78K0/Kx1 Microcontrollers Technical Update	Document No.	ZBG-CC-06-0054	1/2
	Date issued	December 5, 2006	
	Issued by	1st Solution Group Multipurpose Microcomputer Systems Division 4th Systems Operations Unit NEC Electronics Corporation	
Related documents 78K0/KB1 User's Manual: U15836EJ5V0UD00 78K0/KC1 User's Manual: U16227EJ3V0UD00 78K0/KD1 User's Manual: U16315EJ3V1UD00 78K0/KE1 User's Manual: U16228EJ3V1UD00 78K0/KF1 User's Manual: U15947EJ3V1UD00	Notification classification	√	Usage condition
			Upgrade
			Document modification
			Other notification

2. Notification

The following item has been added. See attachment 11 for details.

No. 3 Restriction on POC

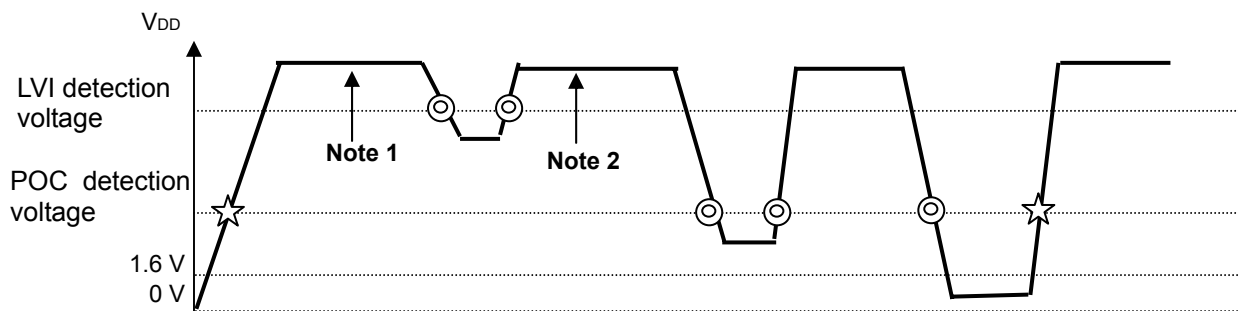
Reset using POC may not be possible immediately after power application.

A reset using POC may not be possible immediately after power application. Therefore, an external reset should be used immediately after power application

A reset using POC at the fall of the power supply and when the voltage is raised from the POC detection voltage $> V_{DD} > 1.6$ V can be generated normally.

In addition, a reset is also generated normally at the rise/fall of the power supply when using LVI with a voltage higher than the POC detection voltage.

Figure: Buffer RAM Configuration

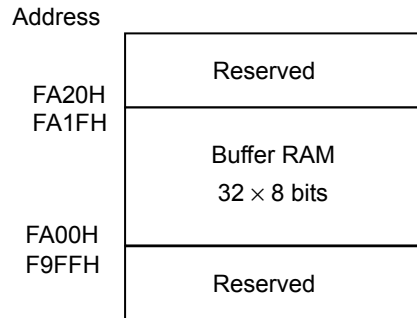
When writing transmit data to the buffer RAM using the 3-wire serial interface with automatic transfer function (CSIA0), data may not be written correctly depending on the instruction executed after the write instruction.

When writing an odd number of bytes (if it is needed to write data to the even address), write dummy data to the buffer RAM at the higher address of the last address.

Write data to the buffer RAM using the 16-bit data transfer instruction only, and then read back the data to compare with the written value. If the data do not match, write the same value again. At this time, it is not necessary to disable interrupts.

<Flowchart of software setting procedure>

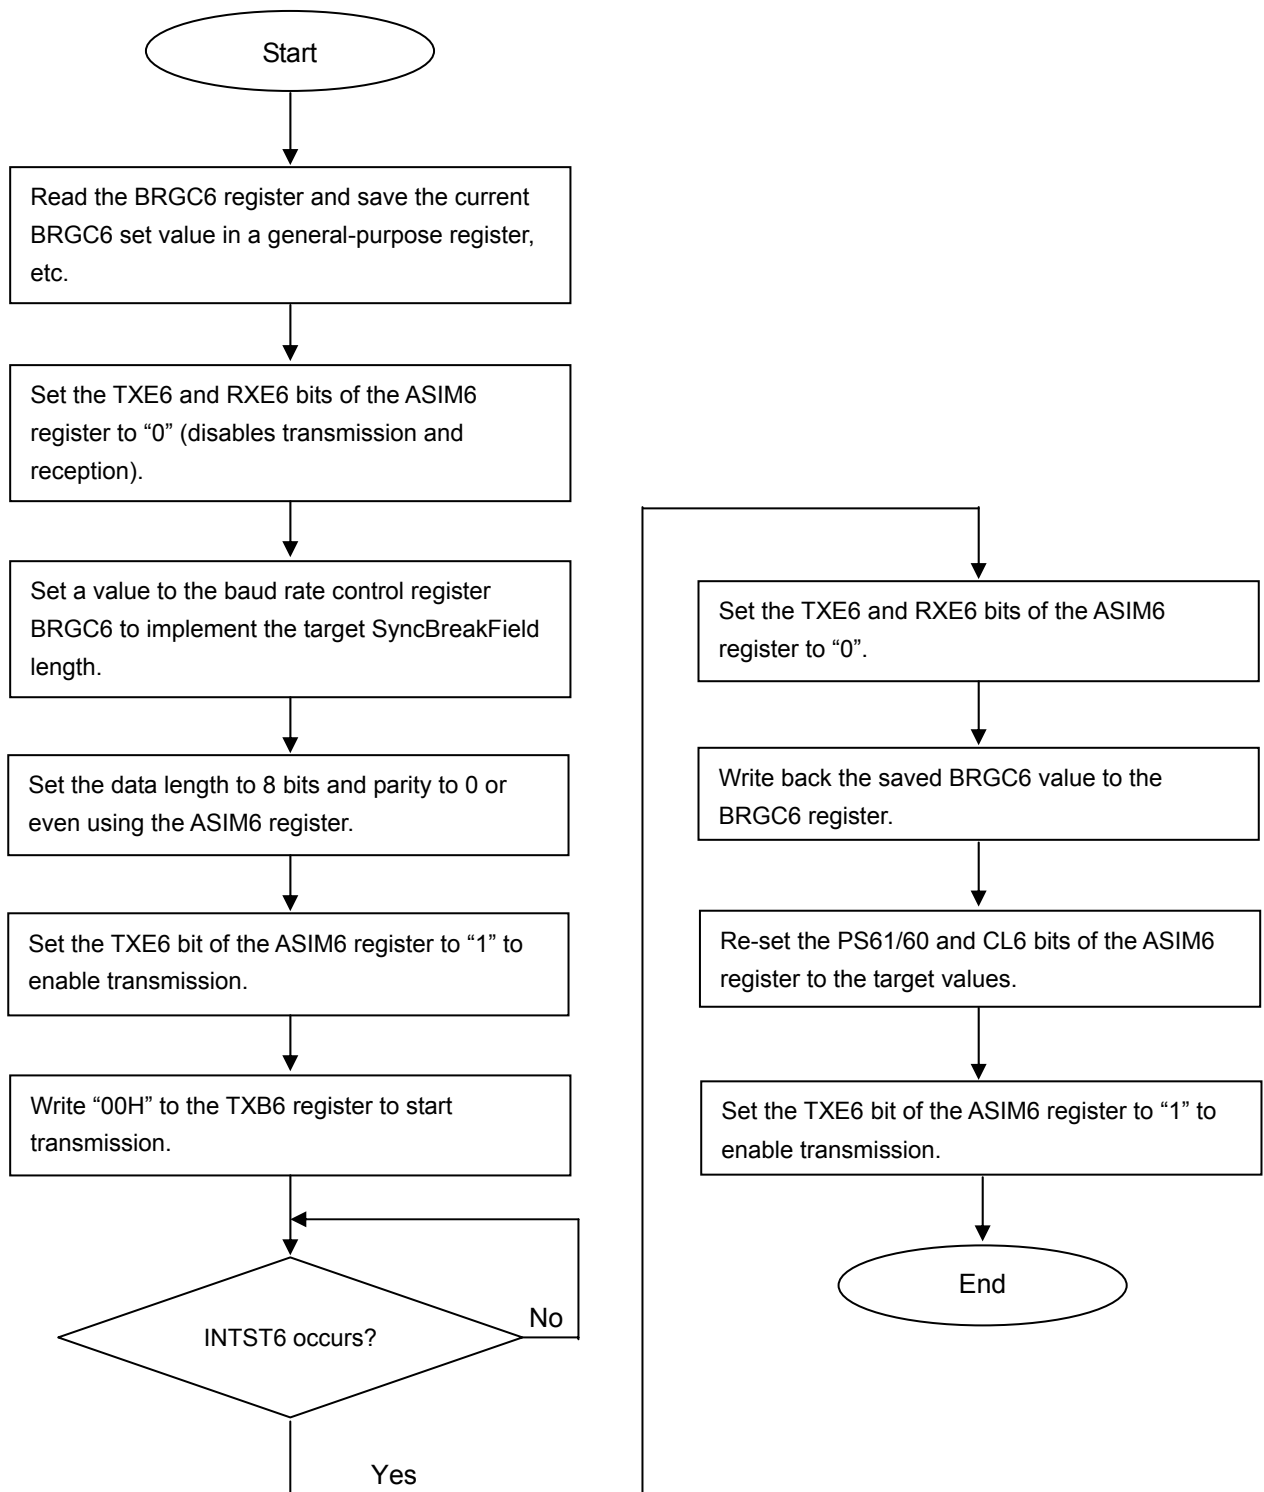
If SyncBreakField transmission is performed when LIN operates as the master in UART6 supporting the LIN-bus, the following illegal operation may be performed.

- (1) A SyncBreakField field length shorter than the set value is output.
- (2) Illegal UART transmission may be performed before SyncBreakField transmission is performed

Perform 13- to 20-bit low-level SyncBreakField transmission by adjusting the baud rate value of the normal UART transmit function.

Set the UART data length to 8 bits, parity to 0 parity or even parity and transmit 00H.

As a result, 10-bit low-level transmission (start bit (1 bit) + data (8 bits) + parity (1 bit)) can be performed. Adjust the baud rate value so that this 10-bit low level matches the target SyncBreakField length.

To implement this 13-bit field length in 10 bits, set a value 1.3 times the target baud rate to BRGC6. In this example, set BRGC6 to 169. The 10-bit low-level transmission length is: $0.2 \mu\text{s} \times 169 \times 2 \times 10 = 676 \mu\text{s}$

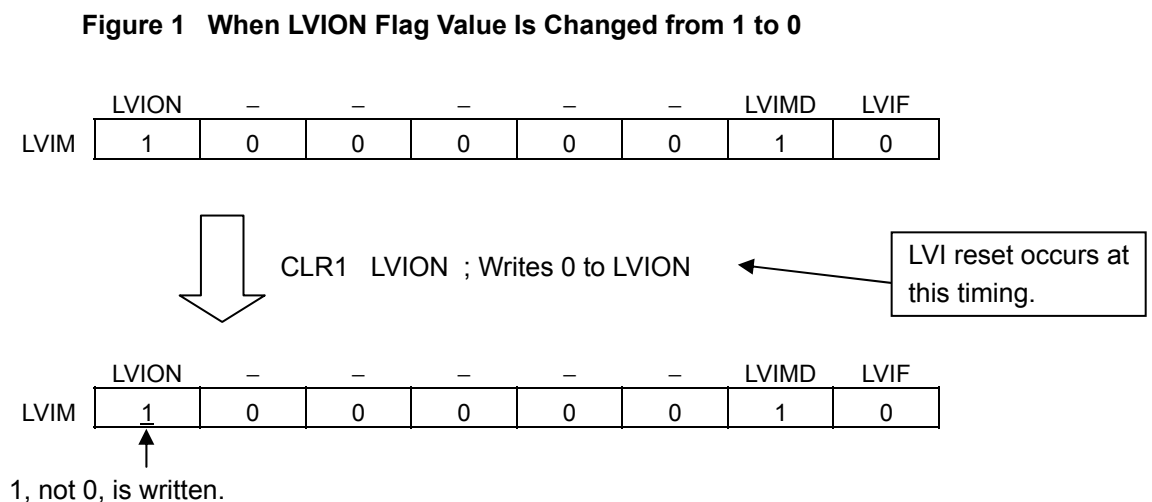
When a reset input by the low-voltage detector (LVI) conflicts with write to a register that sets the LVI operation (LVIM or LVIS), the write-enabled bits of the register may be set to 1. As a result, the following two phenomena occur.

- The reset by the LVI may not stop.
- The voltage detected by the LVI may be lower than the set value or the default value.

Figure 1 shows an example when these phenomena occur due to manipulation of the LVION flag.

- (1) Do not write to the LVIM and LVIS registers after the LVI is set as a reset source.
- (2) Make sure that bit 7 (LVION) of LVIM is 0 before setting the LVIM or LVIS register. If LVION is 1, do not set LVIM and LVIS. By taking this measure, setting of LVIM and LVIS will be performed upon external reset input, POC reset, watchdog timer (WDT) reset or clock monitor (CLM) reset, but will not be performed upon LVI reset.

Figure 2 Example of Conflict Between LVI Reset and LVIM Register Write

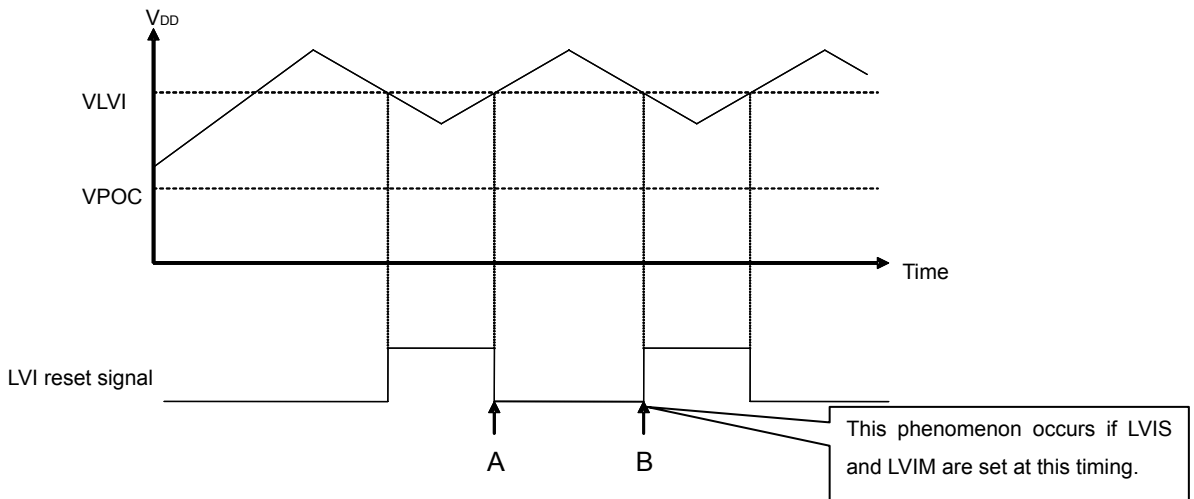
If the VDD voltage varies around the LVI detection voltage (VLVI), the LVI reset occurs several times. In programs in which LVIM and LVIS are always initialized after reset release, if the period from LVI reset release (A in Figure 2) until a LVI reset occurrence (B in Figure 2) matches the time from reset release until initial setting of LVIM and LVIS, this phenomenon occurs.
